# ACCESSIBILITY ASSESSMENT

July 14, 2021

## ADA TITLE II ASSESSMENT

Housing Authority of Prince George's County - Administrative Office  
9200 Basil Court  
Largo, Maryland 20774

<b>Assembly</b>	Interior Access Route
<b>Type</b>	Stairs
<b>ADA Standard</b>	505
<b>Barrier Detail</b>	Handrails are not compliant.
<b>Location Description</b>	Stairwell 2
<b>Observed</b>	Jun 14, 2021 by Ouraccessibleworld@gmail.com

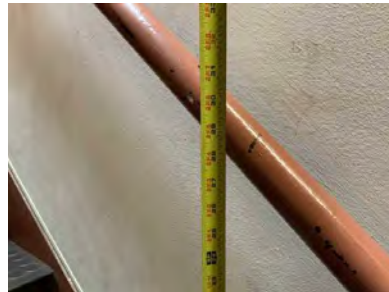
The top of the gripping surface of the handrails is mounted 30" to 31" above the nosing.

Install handrails on both sides of all stairs that comply with guidelines. Handrails shall be provided on both sides of stairs. Handrails shall be continuous within the full length of each stair flight or ramp run. Inside handrails on switchback or dogleg stairs and ramps shall be continuous between flights or runs. Top of gripping surfaces of handrails shall be 34" minimum and 38" maximum vertically above walking surfaces, stair nosings, and ramp surfaces. If children are primary users, provide a second set of handrails with a minimum 9" between lower and higher rail, and the lower rail 28" max. from the walking surface. Handrails shall be at a consistent height above walking surfaces, stair nosings, and ramp surfaces. Clearance between handrail gripping surfaces and adjacent surfaces shall be 1-1/2" minimum. Handrail gripping surfaces shall be continuous along their length and shall not be obstructed along their tops or sides. The bottoms of handrail gripping surfaces shall not be obstructed by newel posts, other construction elements, or obstructions for more than 20% of their length. Where provided, horizontal projections shall occur 1-1/2" minimum below the bottom of the handrail gripping surface. [EXCEPTIONS: 1. Where handrails are provided along walking surfaces with slopes not steeper than 1:20, the bottoms of handrail gripping surfaces shall be permitted to be obstructed along their entire length where they are integral to crash rails or bumper guards. 2. The distance between horizontal projections and the bottom of the gripping surface shall be permitted to be reduced by 1/8" for each 1/2" of additional handrail perimeter dimension that exceeds 4". Handrail gripping surfaces with a circular cross section shall have an outside diameter of 1-1/4" minimum and 2" maximum. Handrail gripping surfaces with a non-circular cross section shall have a perimeter dimension of 4" minimum and 6-1/4" maximum, and a cross-section dimension of 2-1/4" maximum. Handrail gripping surfaces and any surfaces adjacent to them shall be free of sharp or abrasive elements and shall have rounded edges. Handrails shall not rotate within their fittings. Handrail gripping surfaces shall extend beyond and in the same direction of stair flights. At the top of a stair flight, handrails shall extend horizontally above the landing for 12" minimum beginning directly above the first riser nosing. At the bottom of a stair flight, handrails shall extend at the slope of the stair flight for a horizontal distance at least equal to one tread depth beyond the last riser nosing. Extensions shall return to a wall, guard, or the landing surface, or shall be continuous to the handrail of an adjacent stair flight. [EXCEPTIONS: 1. Extensions shall not be required for continuous handrails at the inside turn of switchback or dogleg stairs and ramps AND 3. In alterations, full extensions of handrails shall not be required where such extensions would be hazardous due to plan configuration.] [ADVISORY: It is advisable, but not required, to provide a handrail at a height designed for children. When children are the principal users in a building or facility (e.g., elementary schools), a second set of handrails at an appropriate height can assist them and aid in preventing accidents. A maximum height of 28" measured to the top of the gripping surface from the ramp surface or stair nosing is recommended for handrails designed for children. Sufficient vertical clearance between upper and lower handrails, 9" minimum, should be provided to help prevent entrapment.]

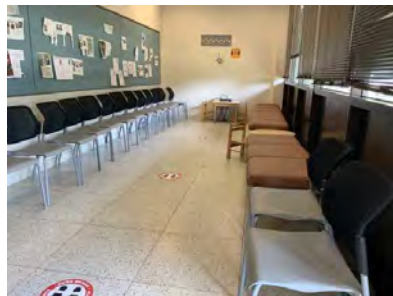
Items requiring an unobstructed side reach motion are higher than 48" maximum and/or lower than 15" minimum height above finish floor.

<b>Location Description</b>	1st Floor Lobby
<b>Observed</b>	Jun 14, 2021 by Ouraccessibleworld@gmail.com
<b>Site Conditions</b>	The drop box slot is mounted at 58" above the floor.

Remove and lower to a compliant reach range. Unobstructed Side Reach: Where a clear floor or ground space allows a parallel approach to an element and the side reach is unobstructed, the high side reach shall be 48" maximum and the low side reach shall be 15" minimum above the finish floor or ground. [EXCEPTION: An obstruction shall be permitted between the clear floor or ground space and the element where the depth of the obstruction is 10" maximum.] [ADVISORY for Children's Forward or Side Reach Ranges: High reach (maximum): 36" for ages 3 to 4; 40" for ages 5 to 8; and 44" for ages 9 to 12. Low reach (minimum): 20" for ages 3 to 4; 18" for ages 5 to 8; and 16" for ages 9 to 12.]

<b>Assembly</b>	Interior Access Route
<b>Type</b>	Door
<b>ADA Standard</b>	404.2.11
<b>Barrier Detail</b>	The bottom of the door vision light is higher than 43" and less than 66".
<b>Location Description</b>	Stairwell 2
<b>Observed</b>	Jun 14, 2021 by Ouraccessibleworld@gmail.com

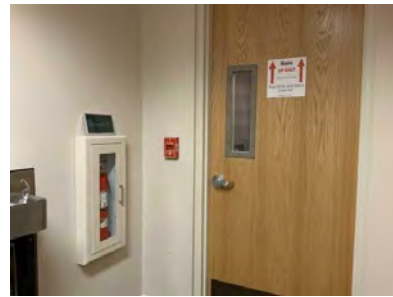
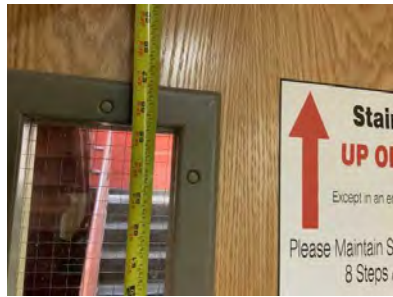
The vision lights at the stairway doors are 45-1/2" above the floor to the bottom of the glazing.

Provide a door with the bottom of at least one of the glazing panels located 43" maximum above the finish floor or grade. At least one of the glazing panels shall be located for viewing through the panels, if the panel is designed for viewing. [EXCEPTION: Vision lights with the lowest part more than 66" from the finish floor or ground are not required to comply.]

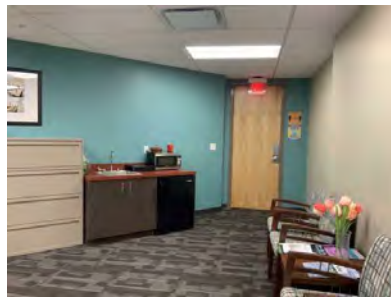
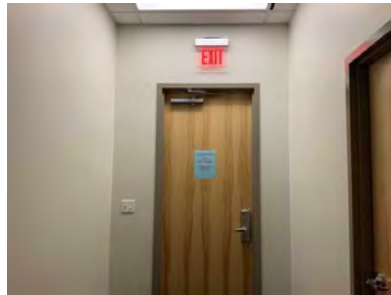
<b>Assembly</b>	Interior Access Route
<b>Type</b>	Signage
<b>ADA Standard</b>	216.4, 703.1, 703.4
<b>Barrier Detail</b>	Means of egress signage is not provided.
<b>Location Description</b>	Throughout the Building
<b>Observed</b>	Jun 14, 2021 by Ouraccessibleworld@gmail.com
<b>Site Conditions</b>	Means of egress signage with tactile characters is not provided at the exits.

Provide compliant means of egress signage at each exit passageway, exit discharge, and exit stairway. Signs at designated egress passageways, stairways, exit doors and areas of refuge shall include tactile signage. Signs shall be installed alongside the door at the latch side. [EXCEPTION: Signs with tactile characters shall be permitted on the push side of doors with closers and without hold-open devices.] Where a tactile sign is provided at double doors with one active leaf, the sign shall be located on the inactive leaf. Where a tactile sign is provided at double doors with two active leaves, the sign shall be located to the right of the right hand door. Where there is no wall space at the latch side of a single door or at the right side of double doors, sign shall be located on the nearest adjacent wall. Where both visual and tactile characters are required, either one sign with both visual and tactile characters, or two separate signs, one with visual, and one with tactile characters, shall be provided. Signs containing tactile characters shall be located so that clear floor space of 18" minimum by 18" minimum, centered on the tactile characters, is provided beyond the arc of any door swing between the closed position and 45 degrees open. Raised characters shall be complaint and shall be duplicated in Braille. Raised characters shall be as follows- Depth: Raised characters shall be 1/32" minimum above their background. Case: Characters shall be uppercase. Style: Characters shall be sans serif. Characters shall not be italic, oblique, script, highly decorative, or of other unusual forms. Character Proportions: Characters shall be selected from fonts where the width of the uppercase letter "O" is 55% minimum and 110% maximum of the height of the uppercase letter "I". Character Height: Character height measured vertically from the baseline of the character shall be 5/8" minimum and 2" maximum based on the height of the uppercase letter "I". [EXCEPTION: Where separate raised and visual characters with the same information are provided, raised character height shall be permitted to be 1/2" minimum.]

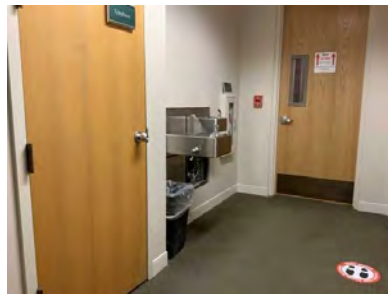
The location of the spout of the wheelchair height drinking fountain is not compliant.

<b>Location Description</b>	2nd, 3rd and 5th Floor
<b>Observed</b>	Jun 14, 2021 by Ouraccessibleworld@gmail.com
<b>Site Conditions</b>	The drinking fountain is mounted with the low fountain at 38" to the spout.

Replace the lower level/wheelchair height drinking fountain to ensure that the spout height is no higher than 36" maximum measured from the finish floor or ground to the spout outlet, and provide knee and toe clearance unless the exception applies. Spout outlets shall be 36" maximum above the finish floor or ground, 15" minimum from vertical support, and 5" maximum from front edge. [EXCEPTION: A parallel approach is permitted at units for children's use where the spout is 30" maximum above finish floor or ground and is 3-1/2" maximum from the front edge of the unit, including bumpers.] Knee Clearance: Space under an element between 9" and 27" above the finish floor or ground shall be considered knee clearance. Knee clearance shall extend 25" maximum under an element at 9" above the finish floor or ground. Where knee clearance is required under an element as part of a clear floor space, the knee clearance shall be 11" deep minimum at 9" above the finish floor or ground, and 8" deep minimum at 27" above the finish floor or ground. Between 9" and 27" above the finish floor or ground, the knee clearance shall be permitted to reduce at a rate of 1" in depth for each 6" in height. Knee clearance shall be 30" wide minimum. Toe Clearance: Space under an element between the finish floor or ground and 9" above the finish floor or ground shall be considered toe clearance. Toe clearance shall extend 25" maximum under an element. Where toe clearance is required at an element as part of a clear floor space, the toe clearance shall extend 17" minimum under the element. Space extending greater than 6" beyond the available knee clearance at 9" above the finish floor or ground shall not be considered toe clearance. Toe clearance shall be 30" wide minimum.

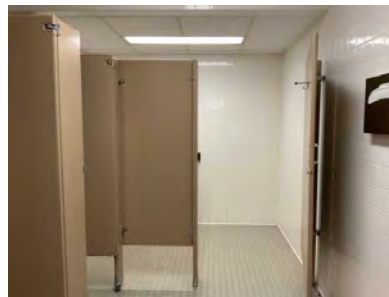
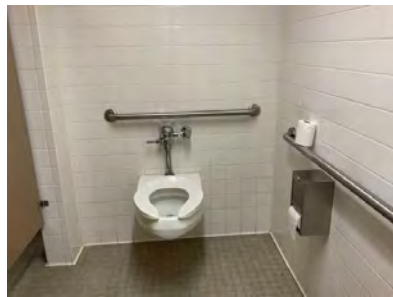
<b>Assembly</b>	Restroom
<b>Type</b>	Restroom/Bathroom - Toilet Stall
<b>ADA Standard</b>	604.5.2
<b>Barrier Detail</b>	The grab bars at the water closet are not compliant.
<b>Location Description</b>	1st and 3rd Floor Men's and Women's Restroom
<b>Observed</b>	Jun 14, 2021 by Ouraccessibleworld@gmail.com

The top of the gripping surface of the grab bars is mounted 36-1/2" above the floor.

Remove and install compliant grab bars. Grab bars shall be installed in a horizontal position at height of 33" minimum to 36" maximum above the finish floor, measured to the top of the gripping surface. The rear wall grab bar shall be 36" long minimum and extend from the centerline of the water closet 12" minimum on one side and 24" minimum on the other side. [EXCEPTIONS: 1. The rear grab bar shall be permitted to be 24" long minimum, centered on the water closet, where wall space does not permit a length of 36" minimum due to the location of a recessed fixture adjacent to the water closet. 2. Where an administrative authority requires flush controls for flush valves to be located in a position that conflicts with the location of the rear grab bar, then the rear grab bar shall be permitted to be split or shifted to the open side of the toilet area.] The side wall grab bar shall be 42" long minimum, located 12" maximum from the rear wall and extending 54" minimum. A continuous grab bar is allowable in lieu of rear and side grab bars. [ADVISORY: It is advisable, but not required, to use the specifications for children where children are the primary users of the restroom. Guidance in applying the specifications for children according to the age group served reflects the differences in the size, stature, and reach ranges of children ages 3 to 12. The specifications chosen should correspond to the age of the primary user group. The specifications of one age group should be applied consistently in the installation of a water closet and related elements. Water Closet Centerline: Ages 3 and 4- 12"; Ages 5 through 8- 12" to 15"; Ages 9 through 12- 15" to 18". Toilet Seat Height: Ages 3 and 4- 11" to 12"; Ages 5 through 8- 12" to 15"; Ages 9 through 12- 15" to 17". Grab Bar Height: Ages 3 and 4- 18" to 20"; Ages 5 through 8- 20" to 25"; Ages 9 through 12- 25" to 27"; Dispenser Height: Ages 3 and 4- 14"; Ages 5 through 8- 14" to 17"; Ages 9 through 12- 17" to 19"].

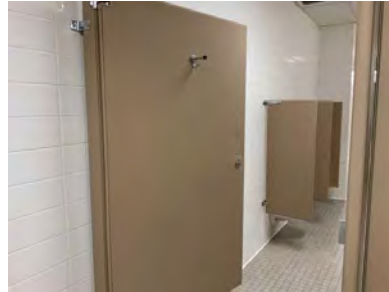
<b>Assembly</b>	Restroom
<b>Type</b>	Restroom/Bathroom-Coat Hook
<b>ADA Standard</b>	308
<b>Barrier Detail</b>	The coat hook is not within an allowable reach range.
<b>Location Description</b>	1st and 3rd Floor Men's and Women's Restroom
<b>Observed</b>	Jun 14, 2021 by Ouraccessibleworld@gmail.com
<b>Site Conditions</b>	The coat hooks are mounted 61" above the floor.

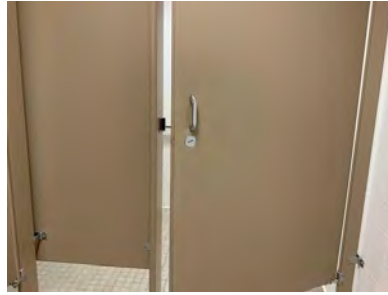
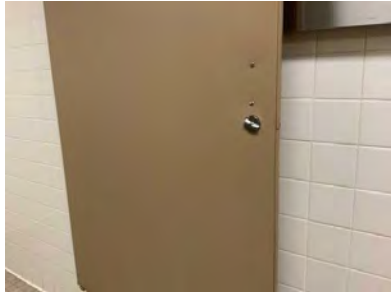
<b>Assembly</b>	Restroom
<b>Type</b>	Restroom/Bathroom-Toilet Stall
<b>ADA Standard</b>	309, 404.2.7, 604.8.1.2
<b>Barrier Detail</b>	The wheelchair stall door is not compliant.
<b>Location Description</b>	1st and 3rd Floor Men's and Women's Restroom
<b>Observed</b>	Jun 14, 2021 by Ouraccessibleworld@gmail.com
<b>Site Conditions</b>	Loop handles are not provided on the inside of the stall doors.

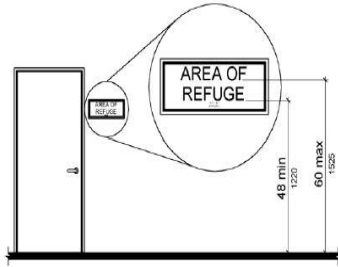
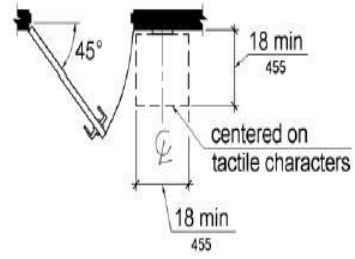
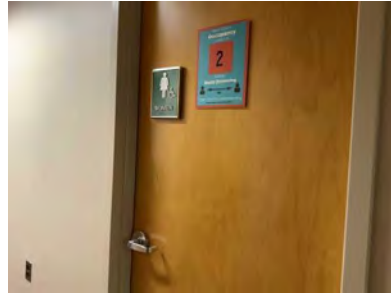
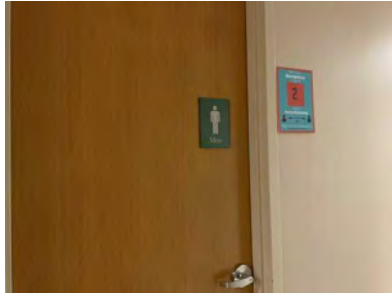
The signage at the restrooms is mounted on the door and does not have the international symbol of accessibility.

Remove and remount signage alongside the latch side of the door mounted at compliant height. Tactile characters on signs shall be located 48" minimum above the finish floor or ground surface, measured from the baseline of the lowest tactile character and 60" maximum above the finish floor or ground surface, measured from the baseline of the highest tactile character. [EXCEPTION: Tactile characters for elevator car controls shall not be required to comply.] Where a tactile sign is provided at a door, the sign shall be located alongside the door at the latch side. Where a tactile sign is provided at double doors with one active leaf, the sign shall be located on the inactive leaf. Where a tactile sign is provided at double doors with two active leaves, the sign shall be located to the right of the right hand door. Where there is no wall space at the latch side of a single door or at the right side of double doors, signs shall be located on the nearest adjacent wall. Signs containing tactile characters shall be located so that a clear floor space of 18" minimum by 18" minimum, centered on the tactile characters, is provided beyond the arc of any door swing between the closed position and 45 degree open position. [EXCEPTION: Signs with tactile characters shall be permitted on the push side of doors with closers and without hold-open devices.]

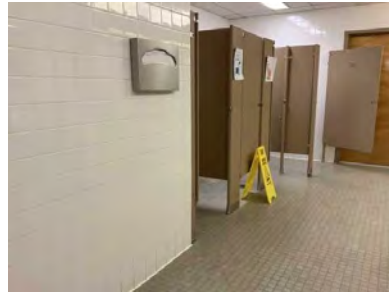
<b>Assembly</b>	Restroom
<b>Type</b>	Controls And Dispensers
<b>ADA Standard</b>	606.1; 309.3
<b>Barrier Detail</b>	The height of controls are not compliant.
<b>Location Description</b>	3rd and 5th Floor Men's and Women's Restroom
<b>Observed</b>	Jun 14, 2021 by Ouraccessibleworld@gmail.com
<b>Site Conditions</b>	The seat cover dispensers ate mounted at 56" above the floor.

Provide operable parts of all controls, dispenser, receptacle and other operable equipment within at least one of the reach ranges. Operable parts shall be placed within one or more of the reach ranges. Unobstructed Forward Reach: Where a forward reach is unobstructed, the high forward reach shall be 48" maximum and the low forward reach shall be 15" minimum above the finish floor or ground. Obstructed High Forward Reach: Where a high forward reach is over an obstruction, the clear floor space shall extend beneath the element for a distance not less than the required reach depth over the obstruction. The high forward reach shall be 48" maximum where the reach depth is 20" maximum. Where the reach depth exceeds 20", the high forward reach shall be 44" maximum and the reach depth shall be 25" maximum. Unobstructed Side Reach: Where a clear floor or ground space allows a parallel approach to an element and the side reach is unobstructed, the high side reach shall be 48" maximum and the low side reach shall be 15" minimum above the finish floor or ground. [EXCEPTION: An obstruction shall be permitted between the clear floor or ground space and the element where the depth of the obstruction is 10" maximum.] Obstructed High Side Reach: Where a clear floor or ground space allows a parallel approach to an element and the high side reach is over an obstruction, the height of the obstruction shall be 34" maximum and the depth of the obstruction shall be 24" maximum. The high side reach shall be 48" maximum for a reach depth of 10" maximum. Where the reach depth exceeds 10", the high side reach shall be 46" maximum for a reach depth of 24" maximum. [ADVISORY for Children's Forward or Side Reach Ranges: High reach (maximum): 36" for ages 3 to 4; 40" for ages 5 to 8; and 44" for ages 9 to 12. Low reach (minimum): 20" for ages 3 to 4; 18" for ages 5 to 8; and 16" for ages 9 to 12.]
